Statutory Comments (07/10/2025)

Your ref: LCC/2023/0030
Our ref: LCC.D2.2023.0030
Date: 7th October 2025

Application no: **LCC/2023/0030**

Address: **Land off Bourbles Lane, Preesall**

Job No:	220503	Drawn By:	J.L.
Date:	Feb 2024	Checked By:	J.L.
Scale:	1 / 100 @ A1	Drawing No:	220503 / 06.2 / A

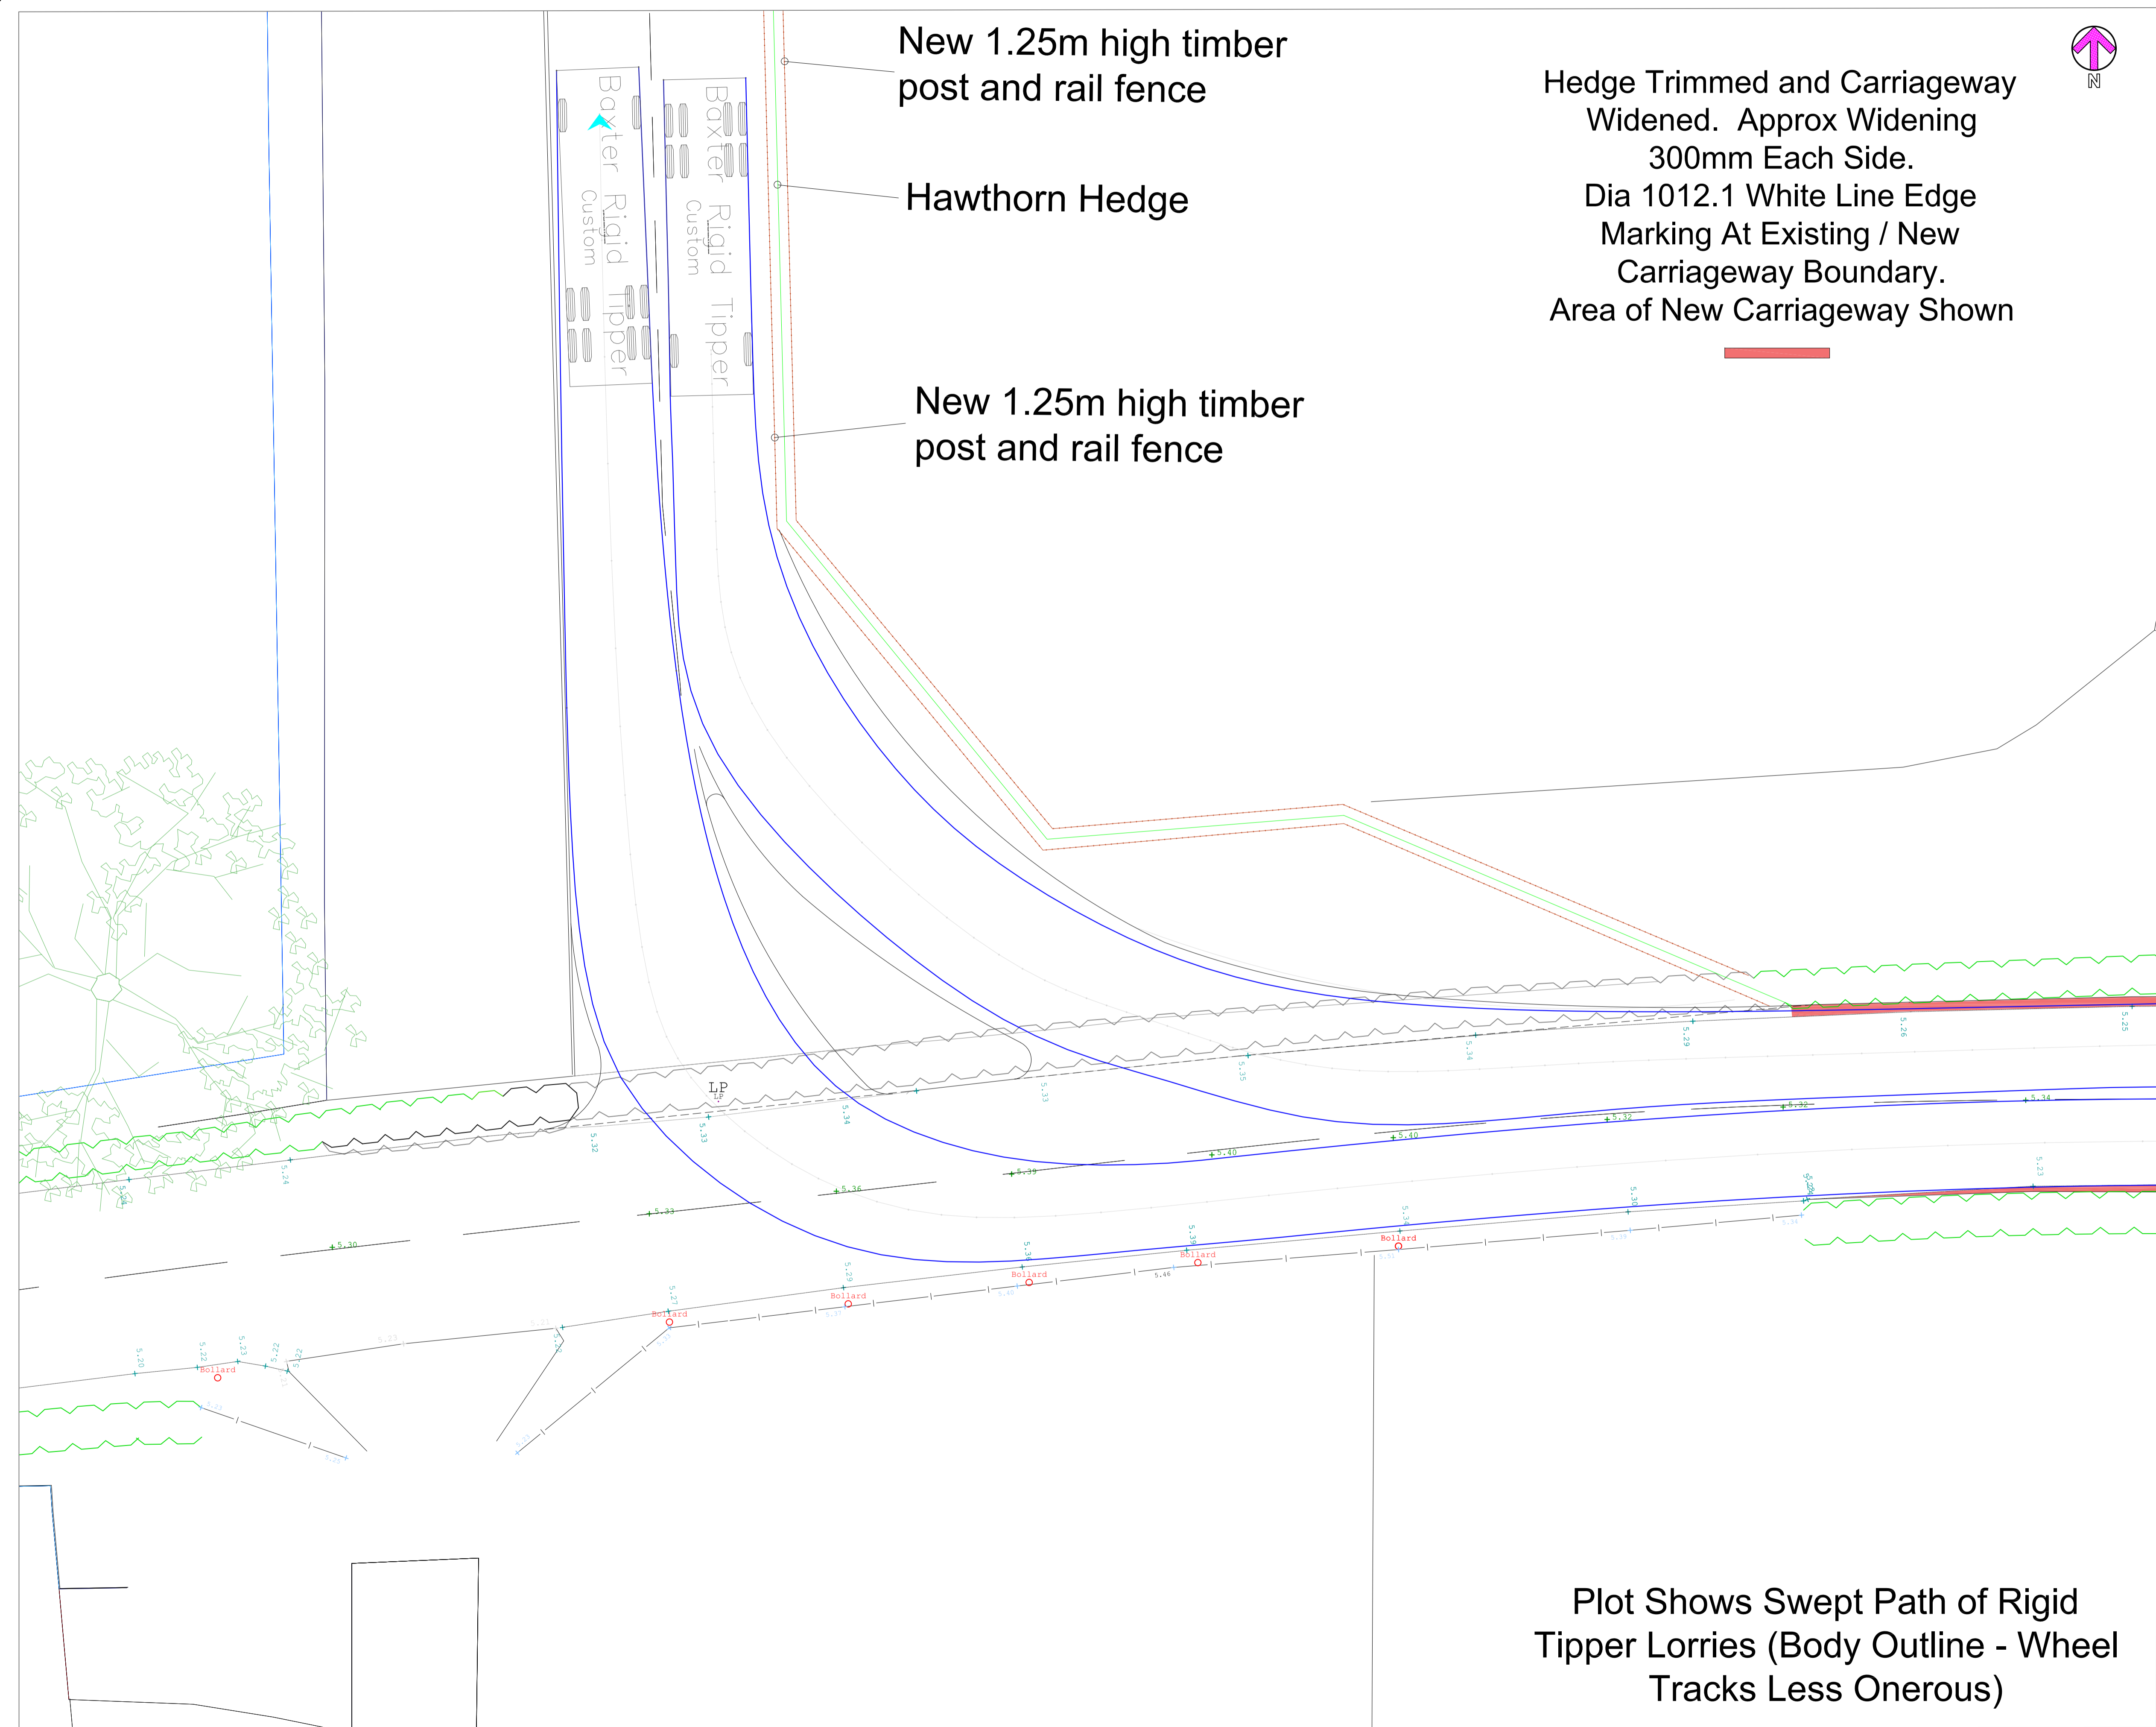
To ensure that the access width can cater for articulated HGV movements, the Agent has provided Turner Lowe drawing number 220503/06.1/A titled "Access Arrangements HGV Manoeuvres Sheet 1" and Turner Lowe drawing number 220503/06.2/A titled "Access Arrangements HGV Manoeuvres Sheet 2." The LHA have reviewed the updated drawings and note that the supplied internal swept path analysis does not take account of the wing mirrors of the HGVs. Therefore, the LHA are unable to fully assess whether two-way HGV movements can occur along the full extents of the access track.

Lancashire County Council Vehicular Visibility
Splay Drawing at the Site Access and Forward
Visibility Splays along Lancaster Road

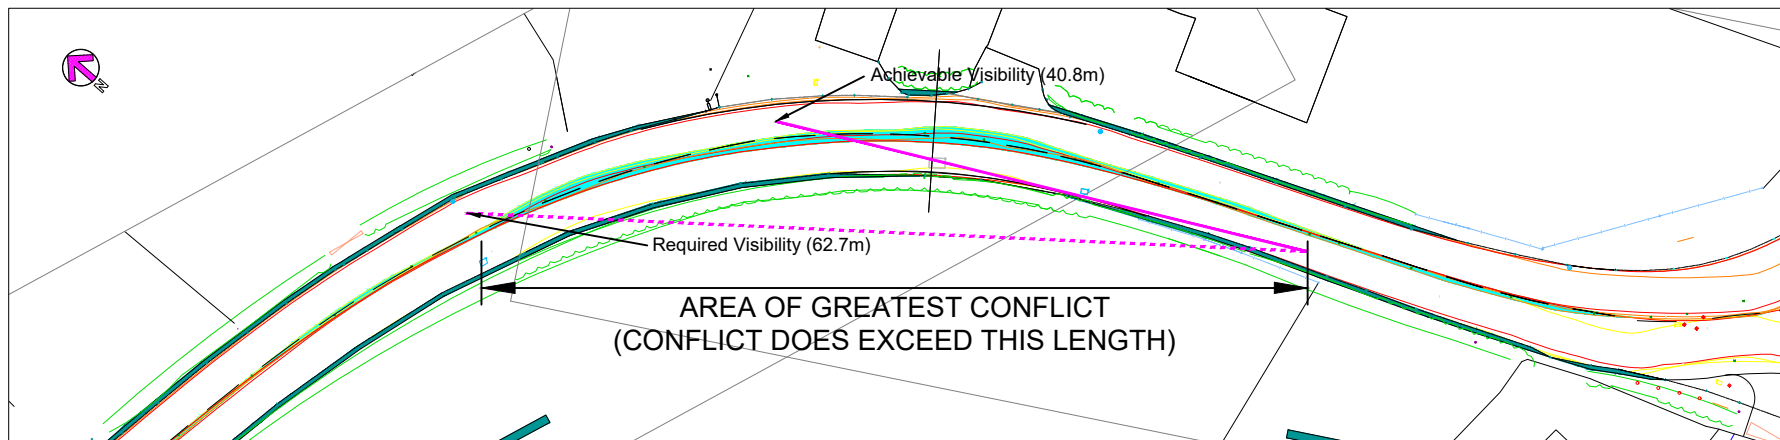
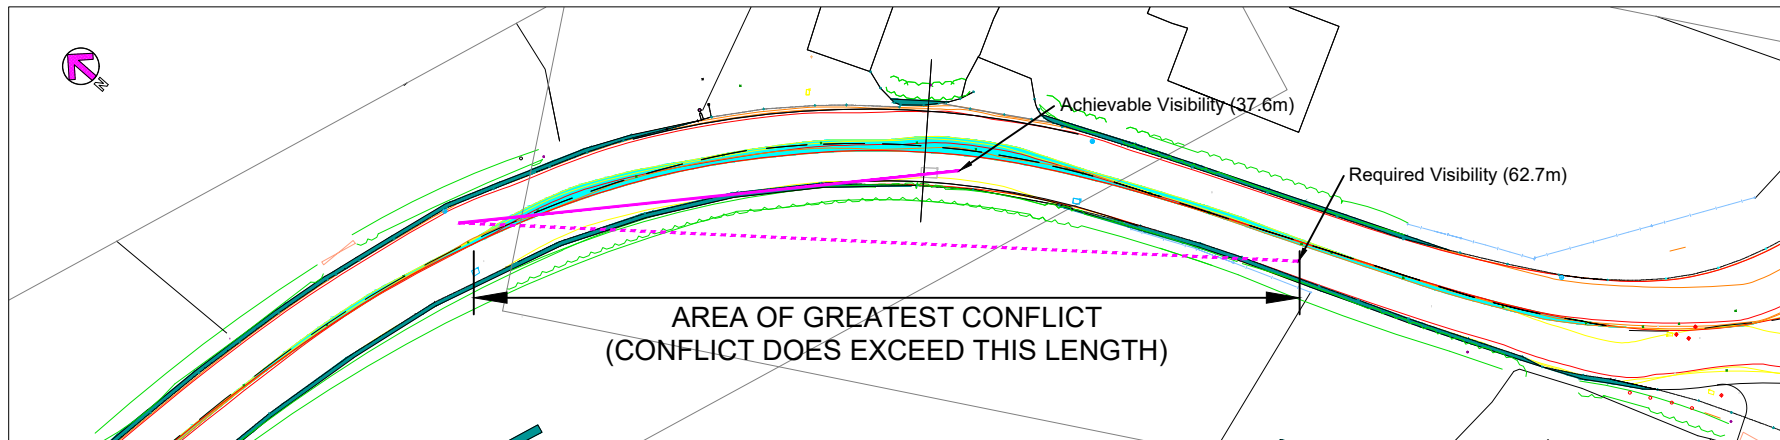
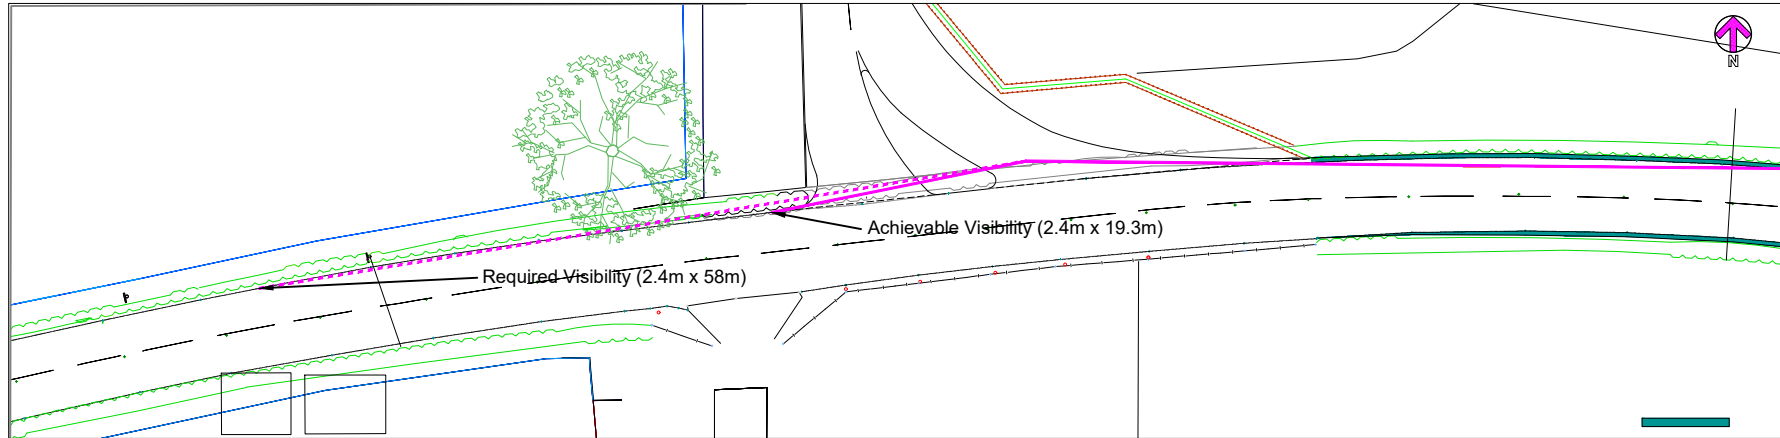
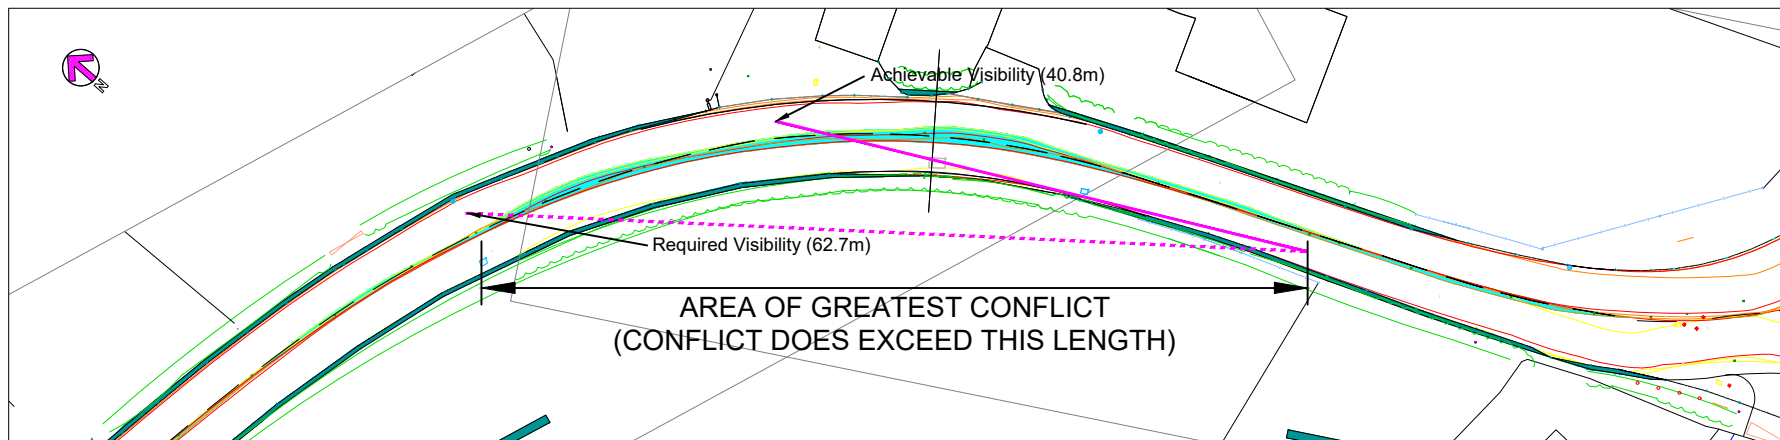
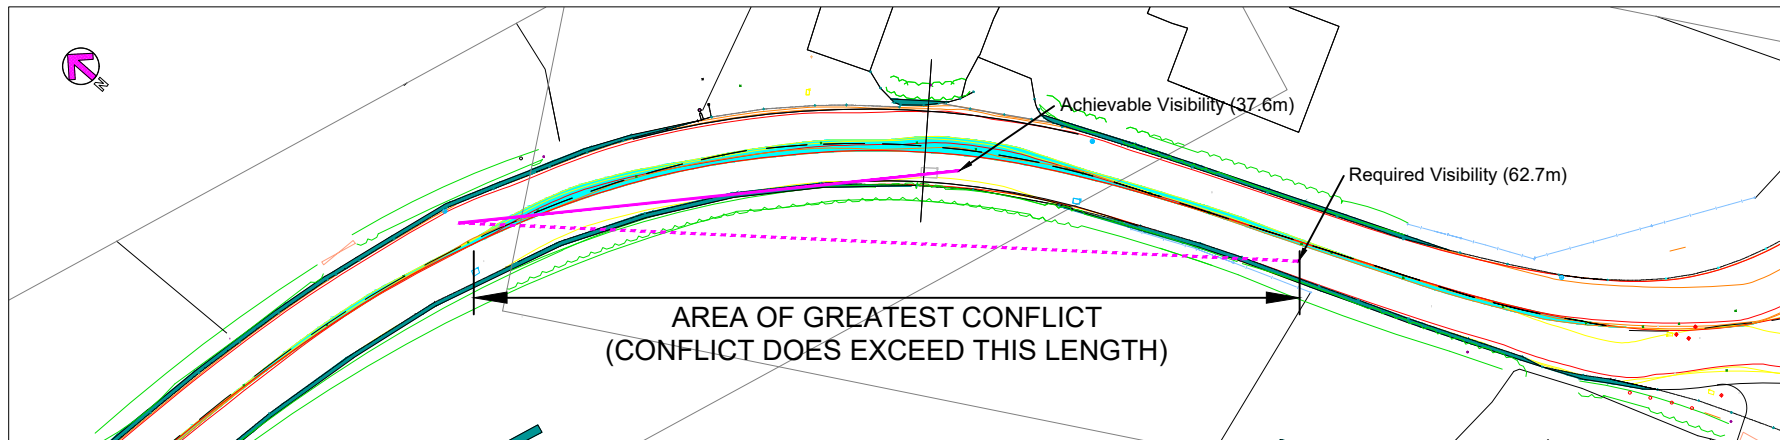
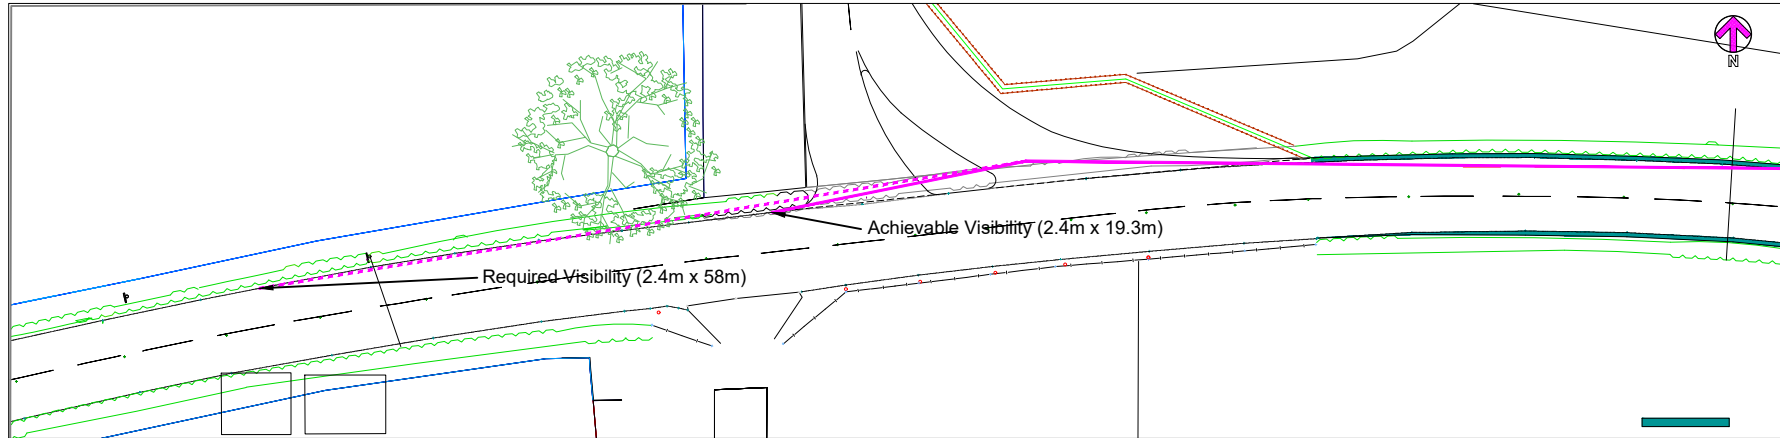
The Agent has submitted a screenshot within the document titled "Response to Highway Authority Consultation Response of 14 February 2025", indicating that visibility splays of 2.4m x 43m in both directions can be achieved. The document also claims that 2.4m x 58m splays are possible, in line with the recorded 85th percentile speeds. However, the screenshot showing the 43m splays is unscaled, and no formal vehicular visibility splay drawing has been provided to verify that the full 58m splays can be achieved. As such, the matter of vehicular visibility remains unresolved and cannot be positively concluded.

For the site to comply with national vehicular visibility splay guidance, an access located off a road which documents speeds of 37mph are required to provide visibility splays of 2.4m x 58m in both directions. However, as shown on Turner Lowe drawing number 220503/05/B, the site can only provide vehicular visibility splays of 1.2m x 43m.

Drawing 1 - 13.9m Tipper Swept Path with Wing Mirror Offset

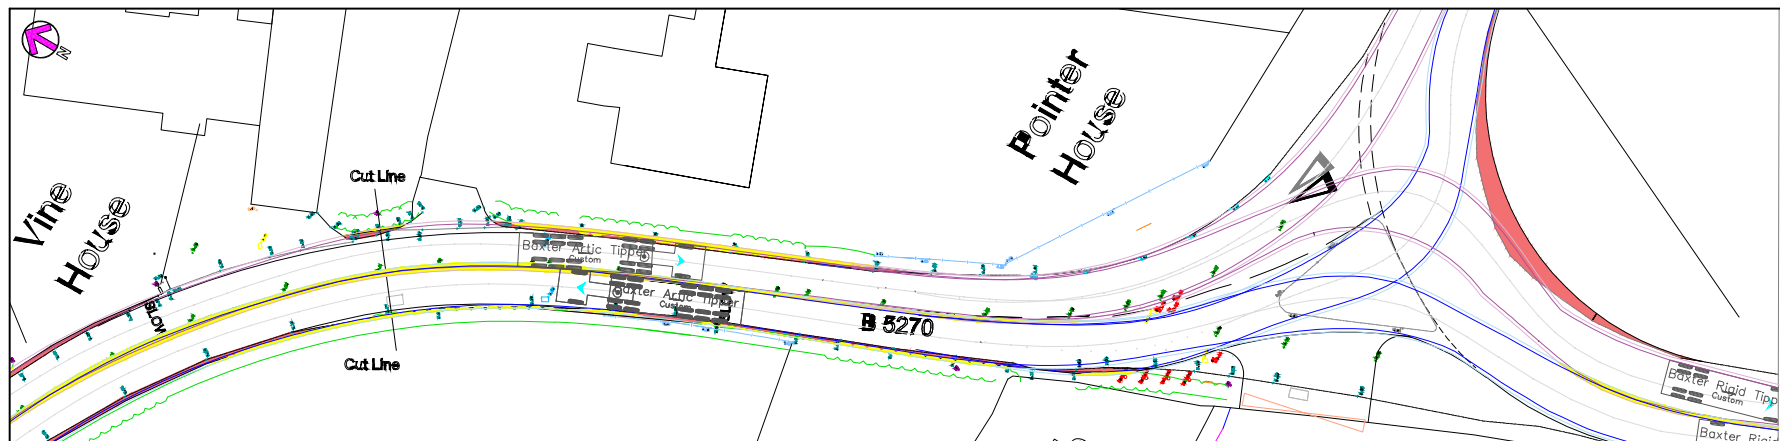
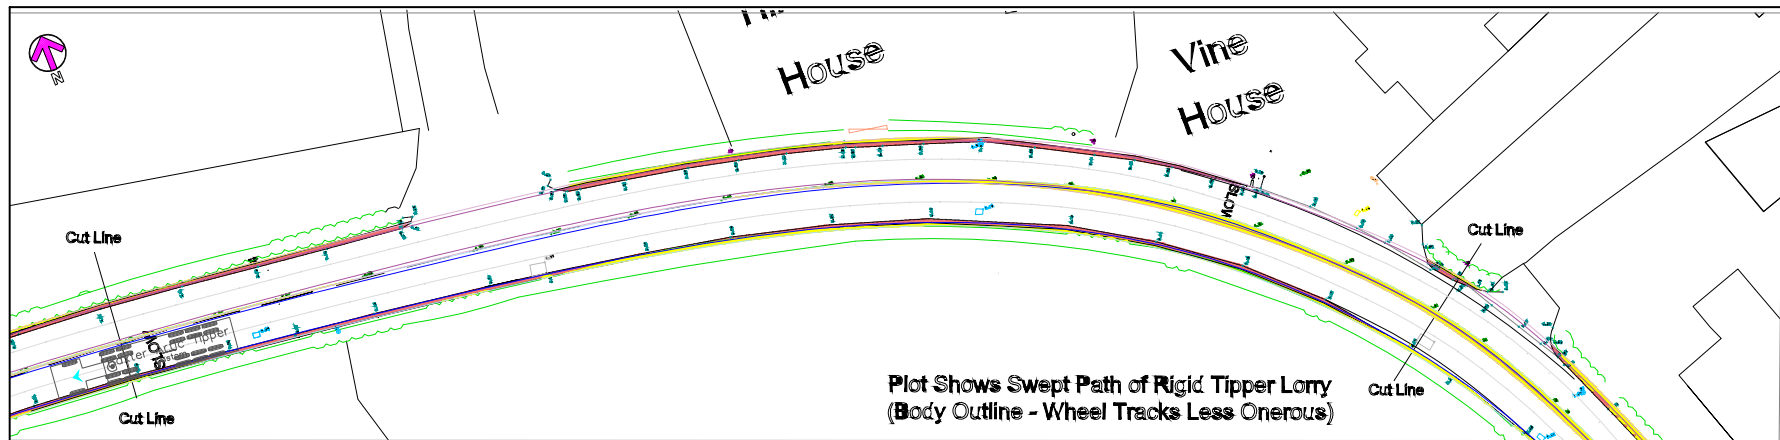
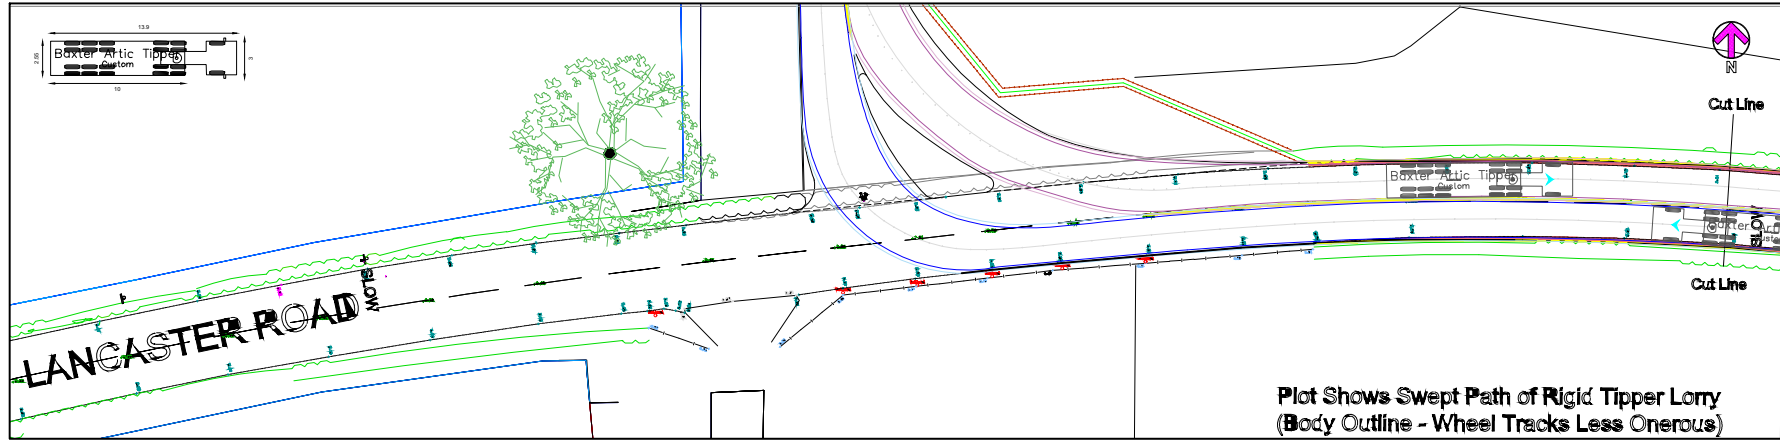
Area of Conflict (vehicle with vehicle or wing mirror with hedge)
